APPEAL SUMMARY

| Appeal ID: 14739 | Project Address: 46 NE Tillamook St |
| Building/Business Name: Tillamook Row - NW | Fire Sprinklers: Yes - 13R Throughout |
| Appeal Involves: Erection of a new structure | LUR or Permit Application No.: 16-280746-CO |

STAIR **OPENING PROTECTION**

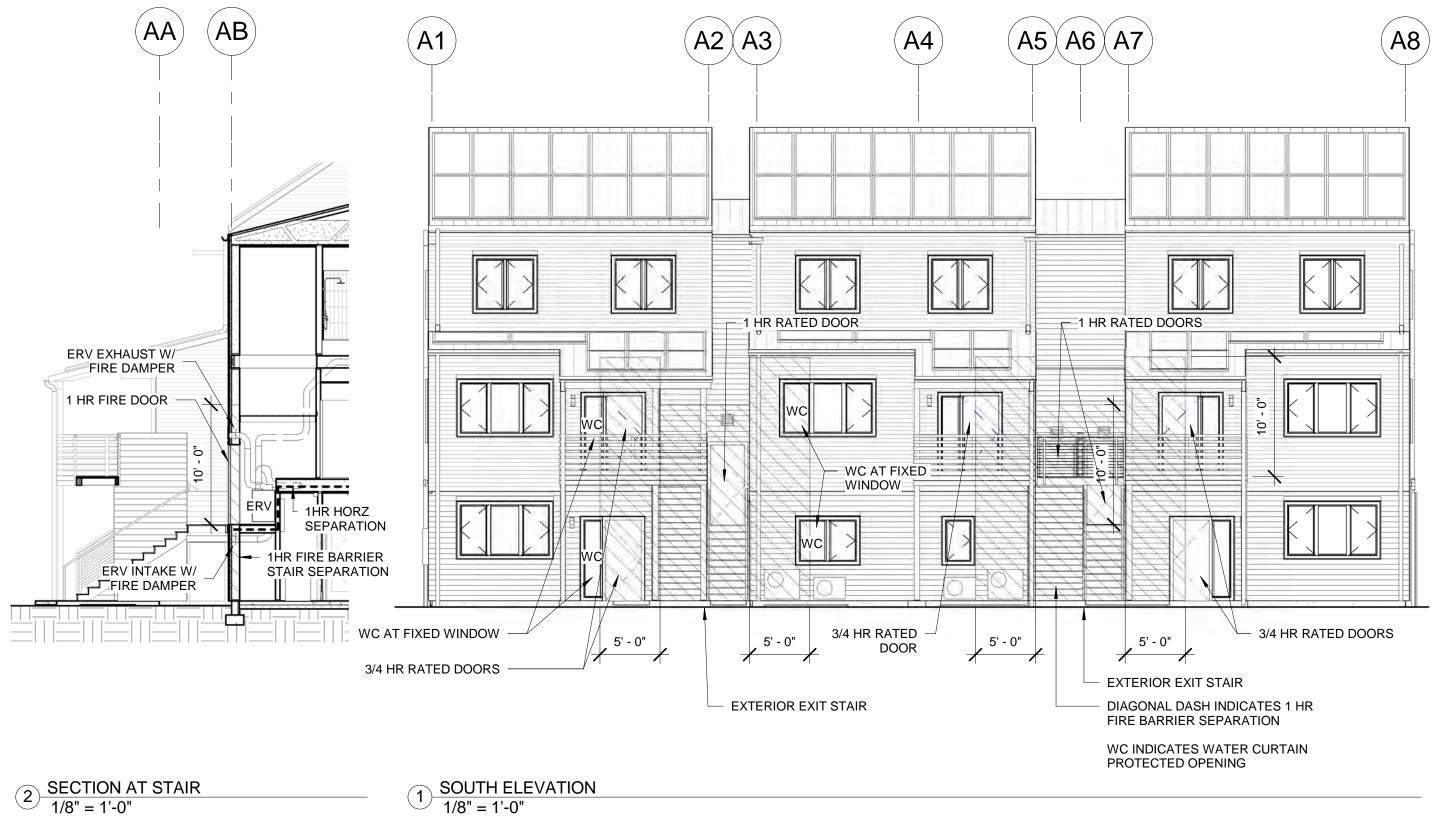
Due to the low occupancy, we propose to provide 1 hour fire-rated exterior walls and protected openings surrounding the stairways and continuing for a minimum distance of 5 feet from the stairways (see attached "Exterior Stair Opening Protection.PDF"). Entry doors will be solid ¾ hour

rated and all glazing within 5 feet shall be fixed windows protected with a closely spaced water curtain sprinkler.

At the mechanical room doors at the stair landings, we propose the use of 1 hour rated fire doors (same rating as the wall) which are self-closing per 716.5.9.

At the ERV ducts we propose 1 hour fusible link fire dampers. At the other doors and windows along the main façade of the building we propose unrated doors and windows with interior closely spaced water curtain sprinklers protecting each opening.

- 1a. 5' of protected openings in walls less than 90 degrees to exterior exit stair, sprinklers in lieu of protected openings: Granted as proposed provided sprinklers are installed a minimum of 4 inches and a maximum of 24 inches from the fixed opening(s) spaced at 6 feet on center. Sprinklers are to be installed on the occupied side of the openings and shall be capable of wetting the entire surface. A separate permit from the Fire Marshal's Office is required.
- 1b. 1 hour fire self-closing door to mechanical room opening to exterior exit stair: Granted provided a sprinkler head is installed within the mechanical room.
- 2. Alternate method for determining fire resistance rating of exterior wall assembly: Denied. Proposal does not demonstrate equivalent fire protection.

1 EXTERIOR WALL PLAN SECTION

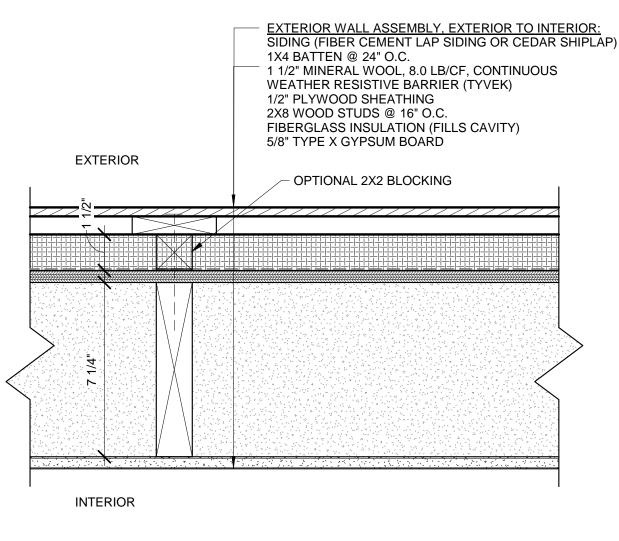
Apply 20 minutes of fire resistance to 2x8 wood studs at 16"o.c.

Apply 15 minutes of fire resistance to a 1 1/2" layer of continuous mineral wool insulation (8.0 lb/cf) on the exterior side of the stud wall, as shown in the wall assembly attached.

The assembly would then have the following fire resistance as calculated per OSSC 722.6.2.1:

Mineral wool to be held in place by 1x4 battens fastened to wall with #8 screws at 24" O.C. max, with min 1" embedment into studs.

Mineral wool proposed is a Non-Combustible material with a Flame Spread rating of 0 and a melting point of 2,150 degrees F (see attached data sheet). A continuous 1 1/2" thick layer of this material would have at least a 15 minute fire resistance, which is equivalent to, for example, a layer of 19/32" plywood per Table 722.6.2 (1). By contrast plywood is a combustible material with a flame spread rating of approximately 100. Further, 1 1/2" of 8.0 pcf mineral wool results in 1.0 psf density of mineral wool material, whereas 722.6.2.5 prescribes 15 minutes of fire resistance to 3.3 pcf mineral wool within a 2x4 stud cavity (which is not continuous) which achieves 0.96 psf density of mineral wool material.

A desired option is to allow 2x2 blocking to break the mineral wool, similar to studs breaking stud cavity insulation, to help keep the siding in a uniform plane.

EXHIBIT A: REVISED WALL ASSEMBLY

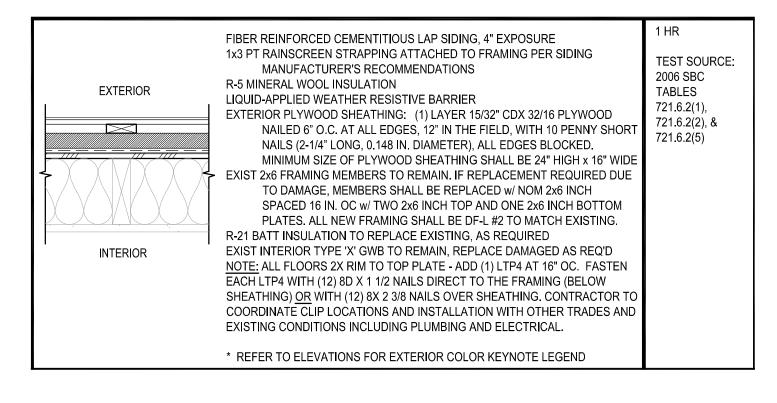
However, you had expressed concerns about this assembly since the proposed layer of mineral wool was discontinuous between the furring strips. Therefore, we have revised the wall assembly detail to show a continuous 1 $\frac{1}{2}$ " thick higher density mineral wool layer, Roxul's ComfortBoard IS, installed over the sheathing. The new proposed mineral wool will increase density and weight from 4.4 PCF to 8.0 PCF. The furring strips will be installed through the mineral wool to the existing studs. The continuous mineral wool will provide enhanced fire resistance and the increased density will improve thermal performance while eliminating thermal bridging. We believe this assembly meets the intent of Section 721, Calculated Fire Resistance, by providing a 1-hour rated wall as tested from the exterior face.

Enclosed with this document is a cut-sheet of Roxul's ComfortBoard IS product, the mineral wool we prefer to use. Also please find a detail of the revised, proposed wall assembly.
